# RX470 rework SOP

## Step 1、 Replace MLCC

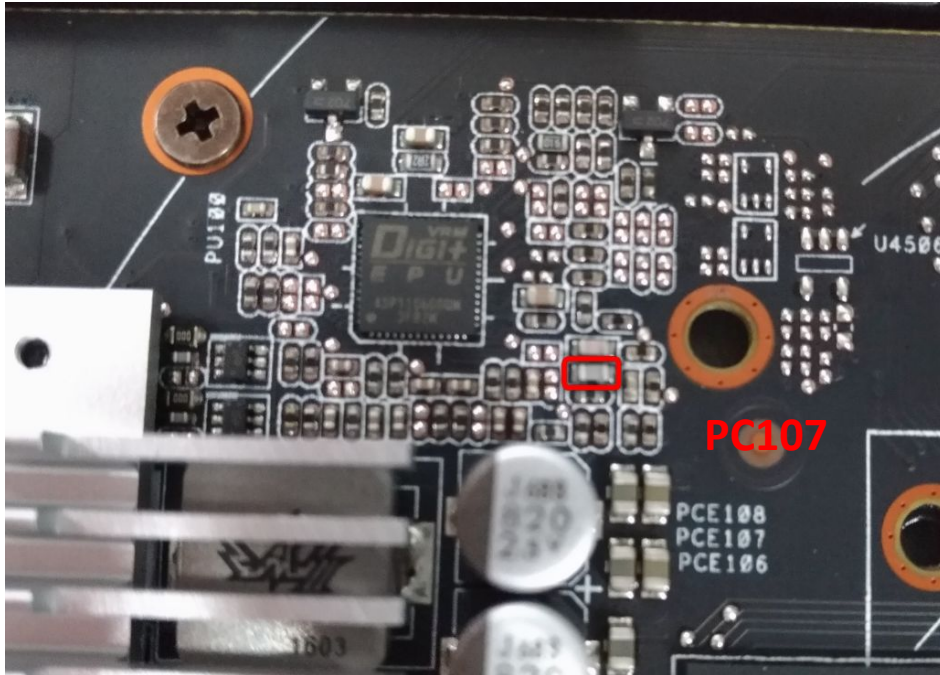
Replace the location MLCC of PC107  
in red circle with 150 pf  
**(PN:11G233015104030)**

## Step2、 Remove MLCC between GND and DGND

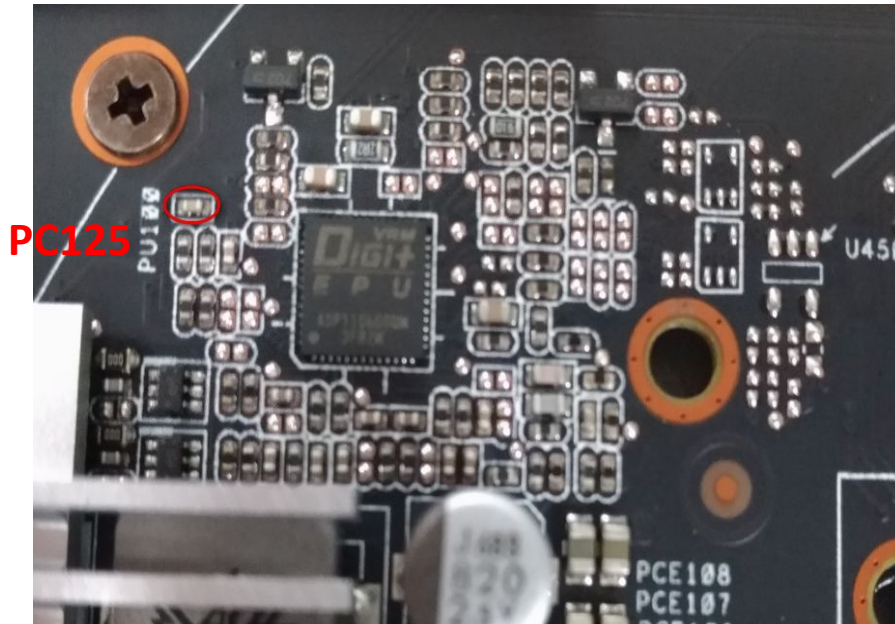
Remove the capacitance of location PC125 in the red circle of the picture
